RE: Water Right, File No. 9921

DWR FIELD OFFICE APPLICATION FOR APPROVAL TO CHANGE THE PLACE OF USE AND/OR THE POINT OF DIVERSION

RE: Application for Change in Point of Diversion
Water Right, File No. 9921

GMD3 Change Review

Point of diversion change application for water right 9921

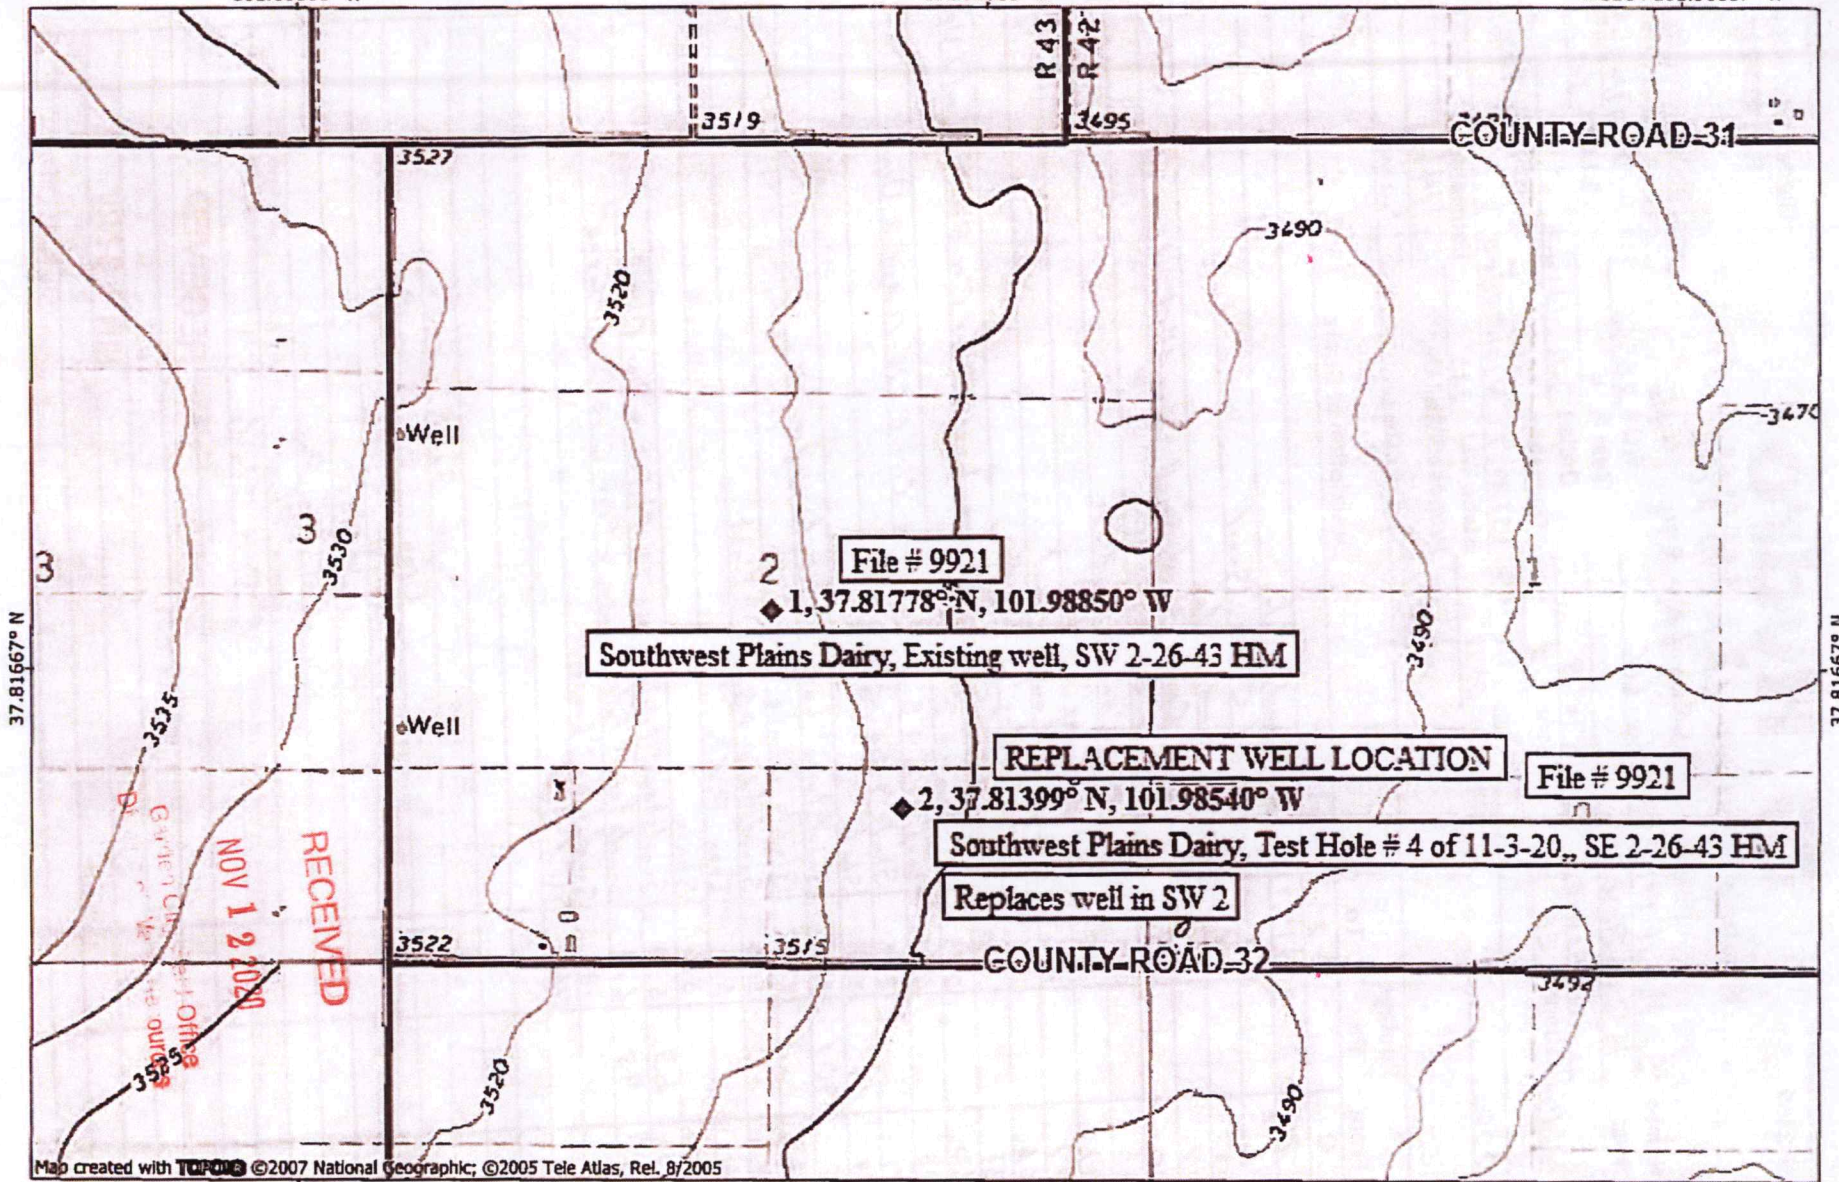
We have completed a review of the application for the above referenced water right. The proposed change in point of diversion is in accordance with current area rules, K.A.R. 5-23-3, as it pertains to distance moved and minimum spacing to neighboring wells.

Well evaluations were conducted to estimate possible effects of the proposal on the supply of other wells with water rights prior to the proposal per K.S.A. 82a-708b, and the draft revised management program. Under K.S.A. 82a-708b, an applicant requesting a change in point of diversion must demonstrate to the chief engineer that any proposed change is reasonable and will not impair. The analysis was more difficult for this area. All wells would be noted as critical. However, the modeling in this area may not always consider the full extent of the aquifer. New updates are hoping to be completed in the near future.

The applicant owns most of the wells in the area, except for one irrigation well and a battery of stock wells, which are owned/operated by one other entity. We contact that neighbor for their perspective on the proposed change. They noted that the applicant is moving further away from their wells and do realize the hydrology for the area. They believe the application should not be hindered and did not want to state any concern for the move, but support. Therefore, GMD3 sees this move as reasonable and therefore recommend that the application be approved. If aquifer conditions change or there is a change to the water right in the future, we would be happy to evaluate the effects at that time.

ft. North	ft. West	
Authorized PD	2495	2665	Sect 2-26-43
Proposed PD	1099	1725	
Difference	1396 s	940 e	
a2 + b2 = c2	1948816	883600	1682.978 foot move SE

Is a waiver needed: Move less than half mile and appears minimum spacing is met.

Recommendation: It has been difficult to evaluate this area on past changes due to the extent of our current models. Since there was only one neighboring well not owned by the applicant, we contacted them personally. They did not object to the proposed change and are aware of the water in that area. It was also discussed that the move would be

away from the neighboring well not owned by the applicant. Staff therefore recommends approval of the application.
